MONITOUCH V9 series
Notice of change in DDR SDRAM
and the associated precautions

This is to inform you that we are going to change a component of MONITOUCH V9 series, DDR SDRAM, to the alternative from the same manufacturer due to the discontinuation of component production. Consequently, the OS of the V9 unit will need to be upgraded, and there are some precautions associated with this change.

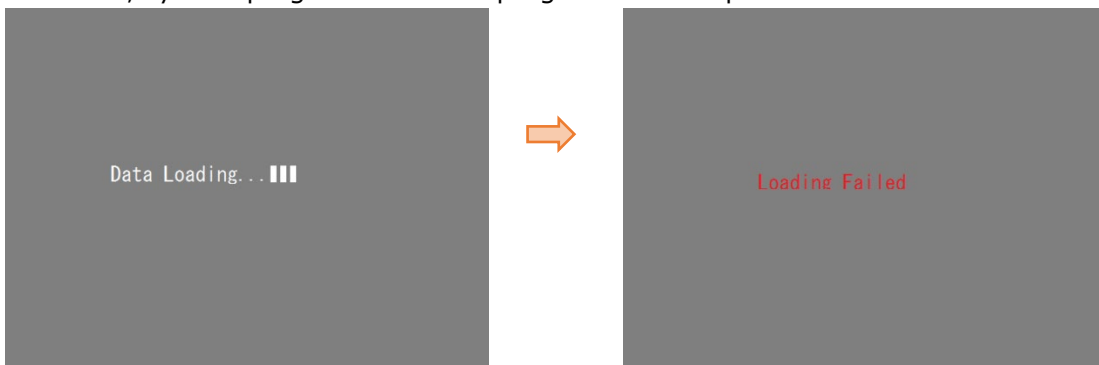
The compatibility of the various programs in the V9 series unit is as follows.

* It is not possible to install unsupported OS (Ver. 1.00 to Ver. 4.30) to the V9 unit with the hardware version "r" and later. Please transfer the OS Ver. 4.40 and later.

Hardware Version	OS	System Program	I/F Driver
a to e	all version	all version	all version
f to k, p	Ver. 3.50 (released in April 2019) and later		
m, q	Ver. 4.30 (released in October 2021) and later	Ver. 2.500 and later	all version except Siemens MPI/PPI
r, s	Ver. 4.40 (released in April 2022) and later *	all version	all version
t, u		Ver. 2.500 and later	all version except Siemens MPI/PPI

[Manual update]

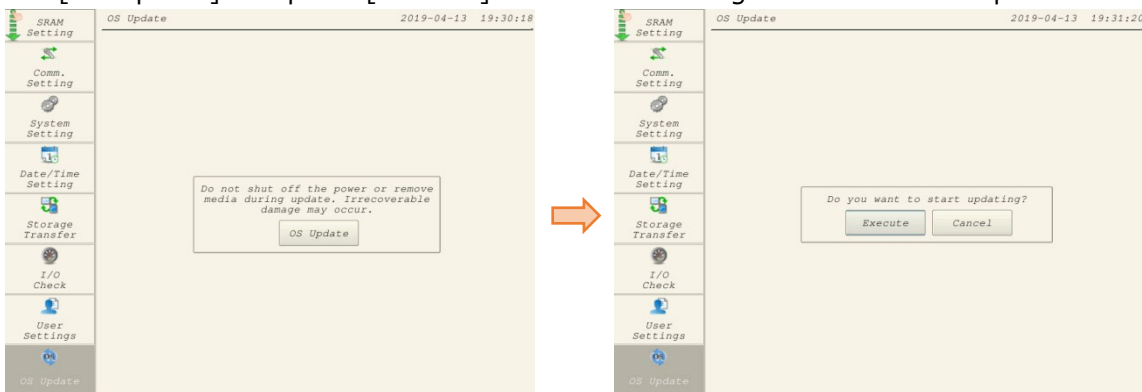
When OS update is performed with Ver. 4.30 or earlier (e.g. case of trying to install OS Ver. 4.30 into the V9 with the hardware version "r"), the following message will appear.

Go to [OS Update] and press [Execute]. Then the V9 will give three short beeps.

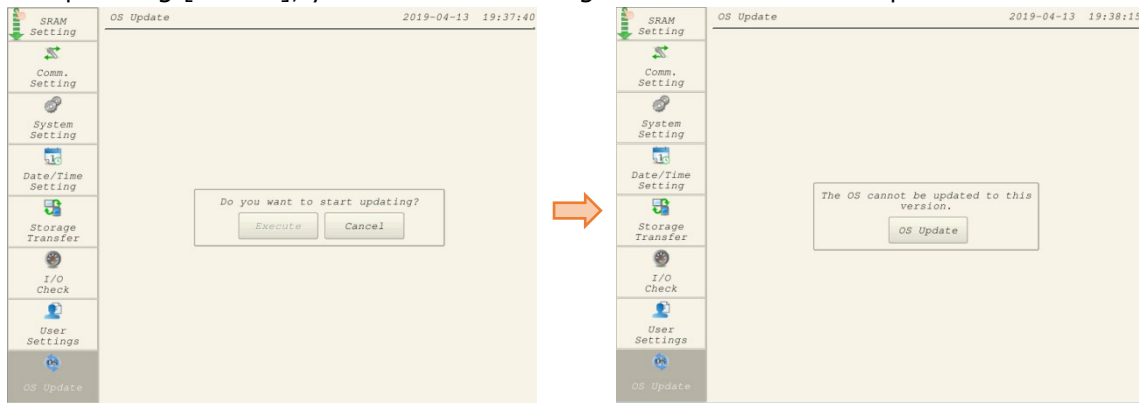
When pressing [Cancel], you will see a message "The OS cannot be updated to this version".
